Submission 4045 (Eric Sahakian, Acton Agua Dulce Unified School District, September 6, 2022)

Palmdale - Burbank - RECORD #4045 DETAIL

Figure 2-53 Burbank Airport Station Preliminary Station Concept Layout Plan

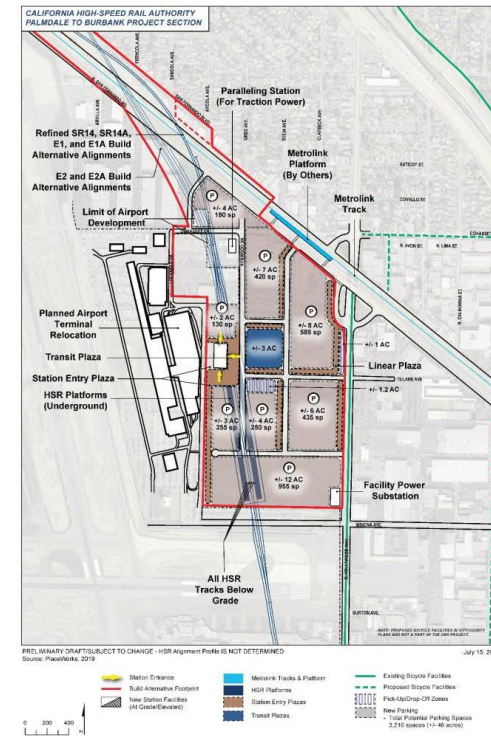
- Page 2-103, Section 2.5.3.1 and page 2-105, Figure 2-53: Although not Airport property, it is important to note that the current land associated with a large portion of the station site and its associated surface parking spaces as depicted in

Figure 2-53 has undergone a significant amount of construction since Figure 2-53 was created. As a result, the description of the area is no longer accurate.

1. The plan layout shown in Figure 2 below indicates the "build alternative footprint" of the CHSRA rail station occupying approximately 70 acres of surface property based on statements given in the Draft EIR/EIS for Palmdale to Burbank Chapter 4 (section 4.4.8.1, page 4-23).
2. Burbank Airport Station is planned to have up to 3,210 surface parking spaces by 2040 with 1,640 spaces operational when the rail system starts up as projected to be 2029.
3. The planned Burbank Airport Station is shown to be directly adjacent to the Planned Airport Terminal Relocation to the west.

The commenter notes changes to the existing land use conditions for a portion of the station site depicted in Section 2.5.3.1 and Figure 2-53 in Chapter 2 of the Draft EIR/EIS, to the east of the Hollywood Burbank Airport. The Authority believes this is a reference to the Avion Burbank development.
